Re: *PennEast Pipeline Company, LLC*, Docket No. CP15-558-000  
Comments on Draft Environmental Impact Statement

**PennEast Pipeline Project**  
**Draft Environmental Impact Statement Comments**  
**Docket No. CP15-558-000**  
**FERC EIS: 0271D**

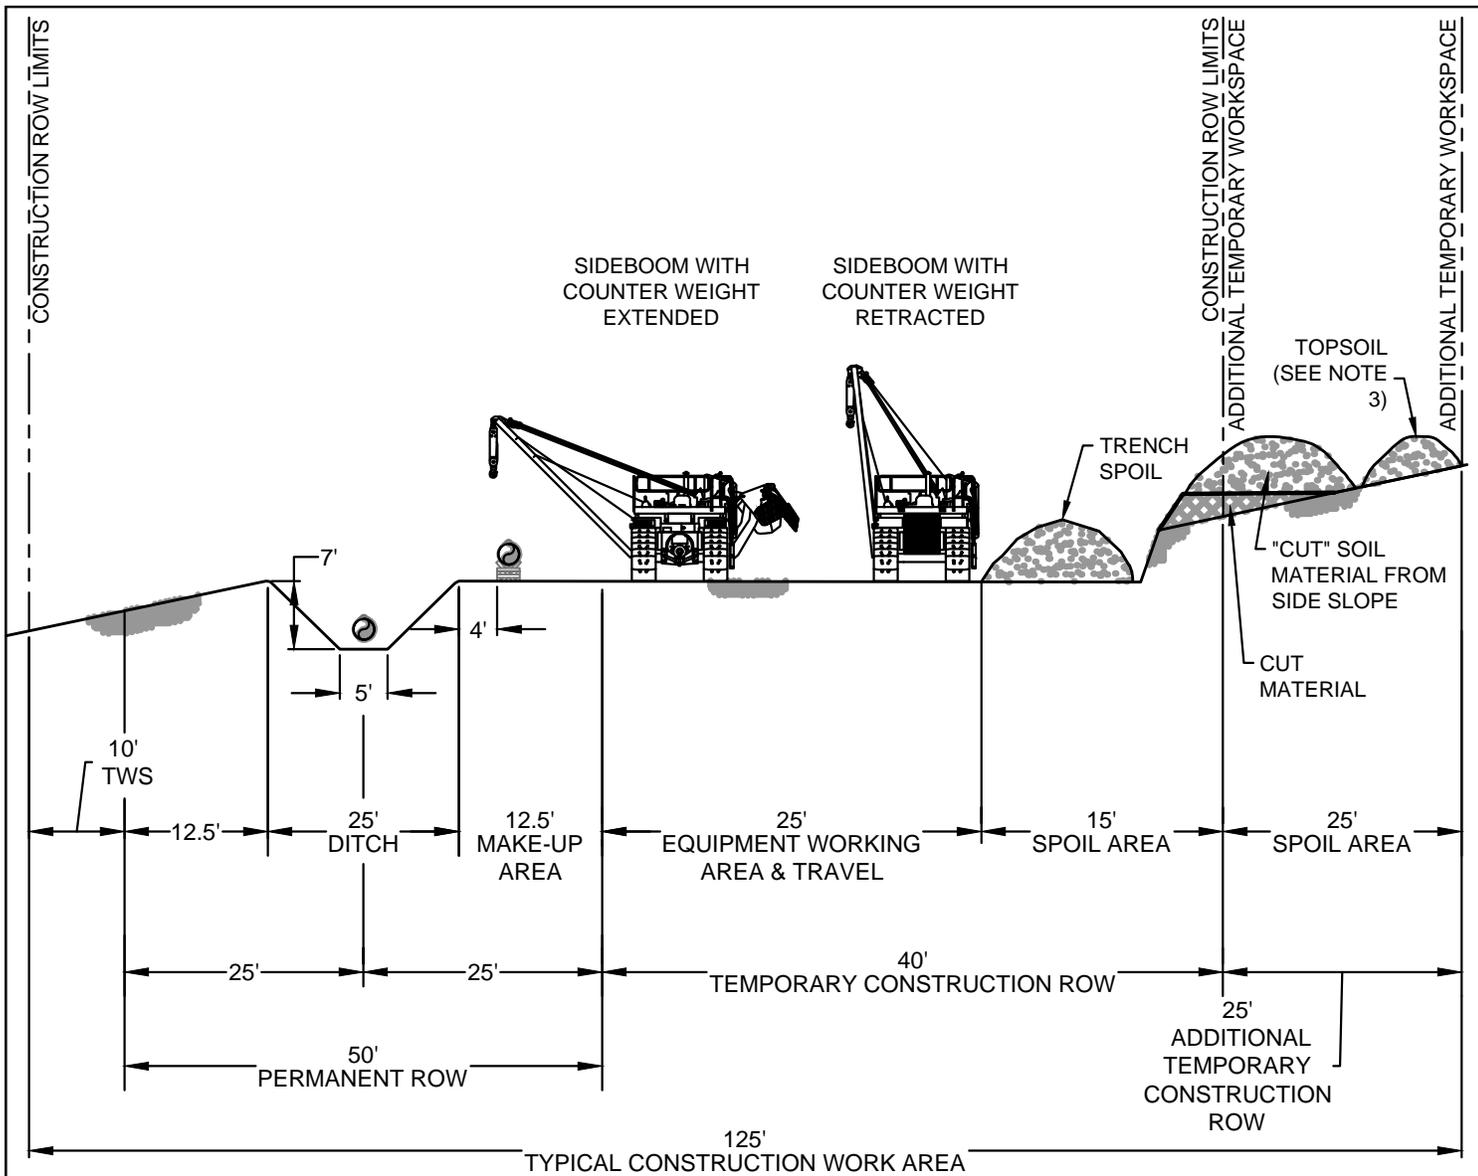
First, it is not reasonable to assume that the 1.1 million dekatherms per day of natural gas that the Project could deliver to customers in the region would result in wholly additive emissions. Indeed, in Sections 4.12.5 and 5.1.12, the Commission acknowledges the potential for natural gas delivered by the Project to displace more polluting fossil fuels. Accordingly, if the Commission presents aggregate potential GHG emissions based on the pipeline's throughput capacity, the Commission must also discuss the likelihood that displacement will occur that will offset some portion (or, possibly, the entirety) of those emissions.

FIGURE NUMBER: **FIGURE 1B**

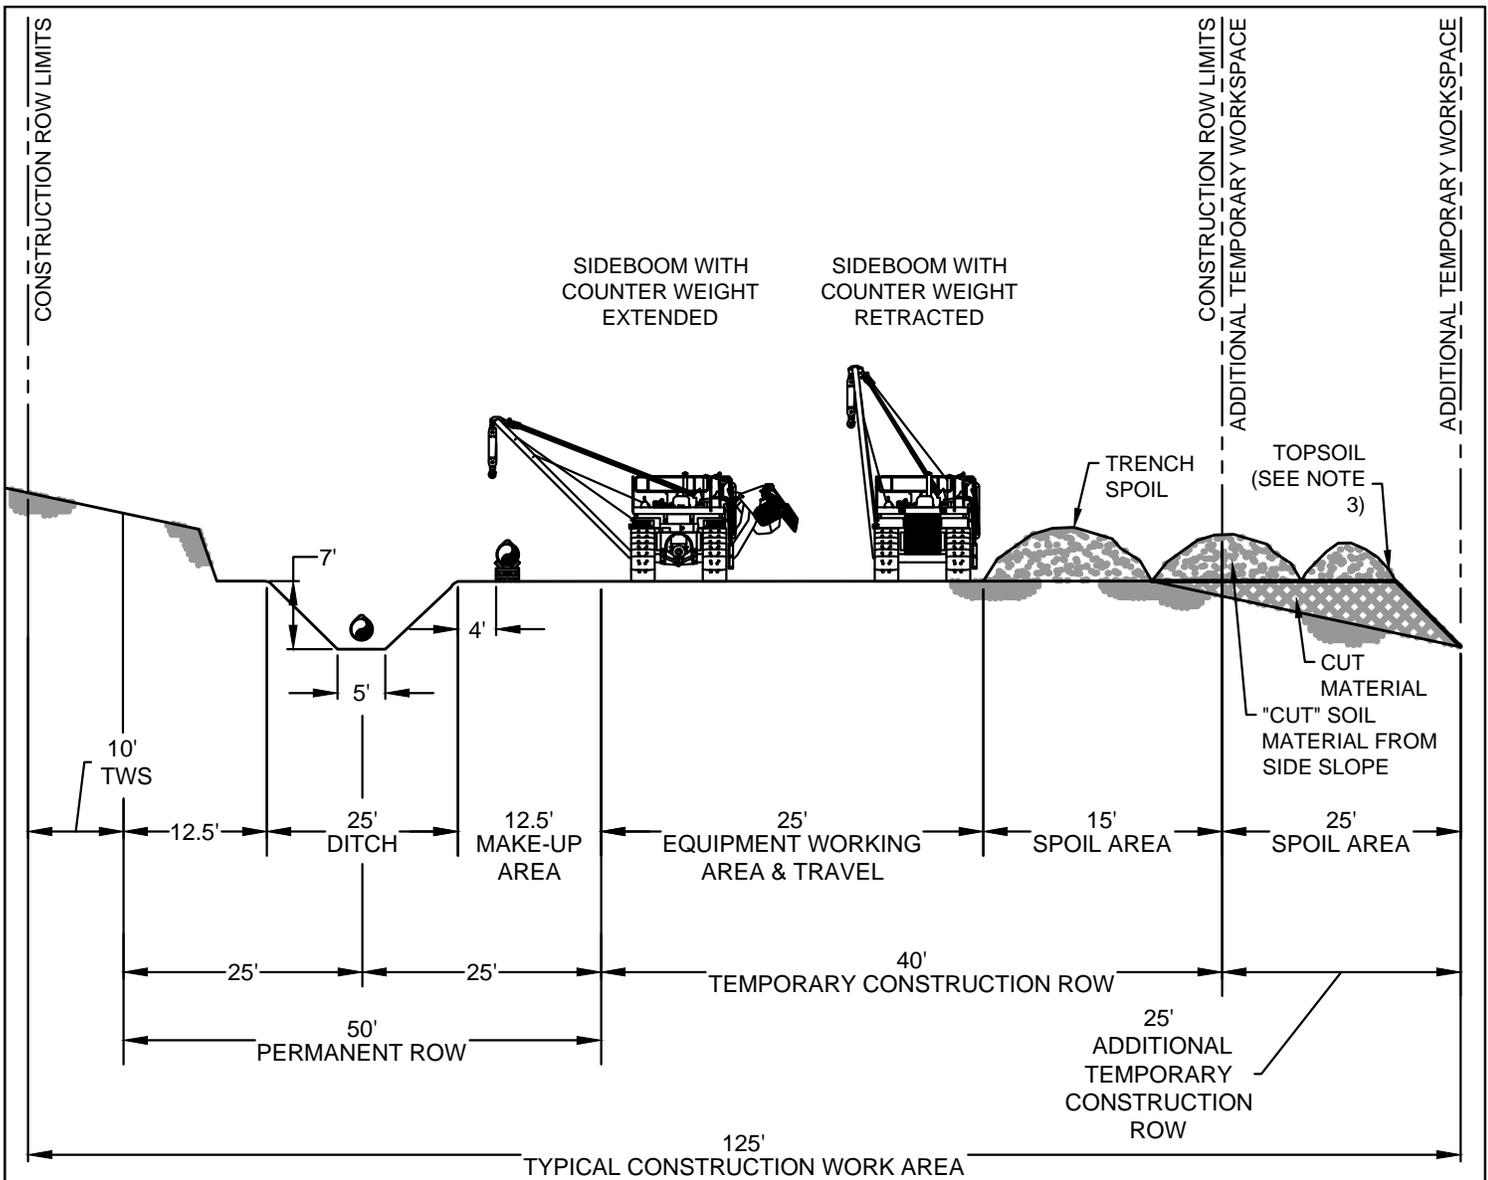
DEIS Section	Page No.	Paragraph/ Table/ Figure No.	Text	Comment	Suggested Resolution
			relatively minor overall. However, some long-term cumulative impacts would occur on wetland and forested vegetation and associated wildlife habitats. Water resources could potentially be negatively impacted by arsenic released by blasting activities associated with multiple projects.”		However, some long-term cumulative impacts would occur on wetland and forested vegetation and associated wildlife habitats. Water resources could potentially, but will unlikely, be negatively impacted by arsenic released by blasting activities associated with multiple projects (see Section 4.1.5.5).”
Appendix C	N/A	Figure 1B	Typical Upward Side Slope Workspace Construction Area	Workspace measurements were incorrect in the Typical Drawing included in the DEIS.	Replace Figure 1B with the revised Figure 1B, provided herein as part of Attachment 3.
